# Southampton to London Pipeline Project

Site Specific Plan - St James' School  
(tracked change)

Application Document: 8.62

Revision No. 2.0

**Illustration 3.2: Trenchless crossing from Clarendon School to St. James School (TC041)**

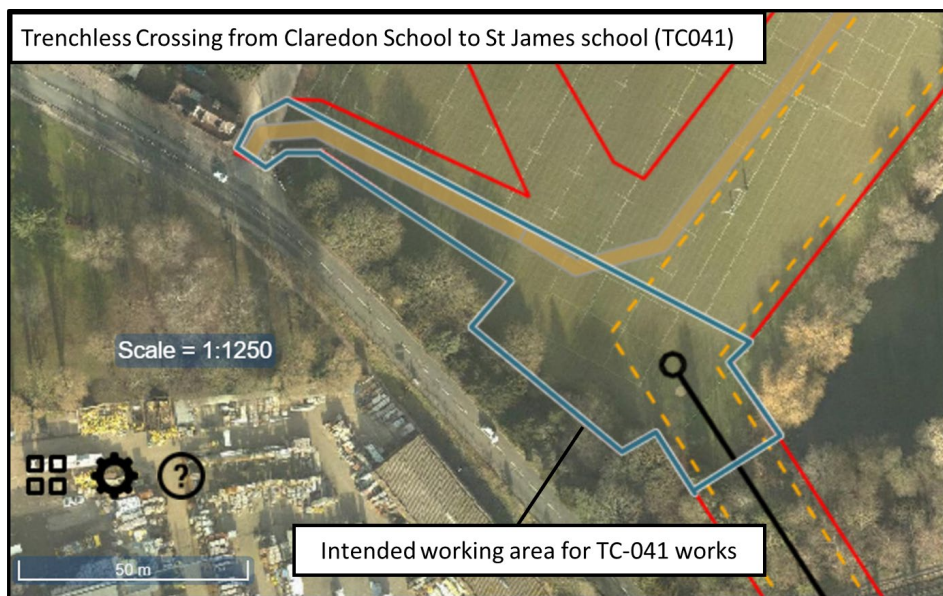
3.4.13.5.2 The receiving area for TC041 from Clarendon School to St James School will require a receiving shaft in the southeast corner of the southern playing fields, adjacent to the boating lake. The drive pit methodology is covered in the Site Specific Plan for Ashford Road.

3.4.23.5.3 The proposed trenchless work area is indicated in the image below.

3.4.33.5.4 Installation will follow the standard auger bore methodology, as described in the CoCP. Ground protection will be laid to create the access route from the school's entrance to the working area, in order to reduce impacts on the playing fields.
